Registration Date:	21 June 2023	Application No:	P/01175/016
Officer:	Shivesh Seedhar	Ward:	Cippenham Green
Applicant:	Miss Eleanor Smith, Ibradavid House Ltd	Application Type:	Major
		13 Week Date:	20 September 2023
Agent:	Miss Eleanor Smith, Danks Badnell Architects Ltd. Kings Stables, 3-4 Osborne Mews, Windsor, SL4 3DE		
Location:	397 Bath Road, Slough, Berkshire, SL1 5QA		
Proposal:	Demolition of all temporary structures on the site, construction of a part four, part five storey apartment building to the northern frontage of the site, formation of a landscaped parking court and construction of five 2 storey cottages to the south with the first floor set within the roof.

**Recommendation:** Delegate to Planning Manager for Refusal

**Appendix 2: Receptor 1 – South Façade Window Locations**

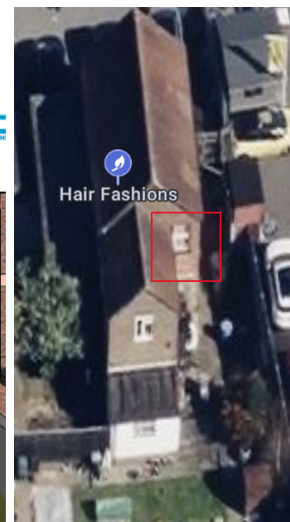
Below images: Side-by-side comparison with No. 399 Bath Road, existing (right), and the proposed assessed scenario (left) (taken from Daylight and sunlight assessment).

Given the above and considering that the ground floor window within the same location (albeit a level higher), may not experience sufficient daylight levels and may be considered unacceptable in view of the overall very high adherence set out in BRE Guide target criteria. As such, due to the inaccurate and insufficient information provided, the proposed development would have a harmful impact on the residential amenity of occupiers of No. 399 Bath Road.
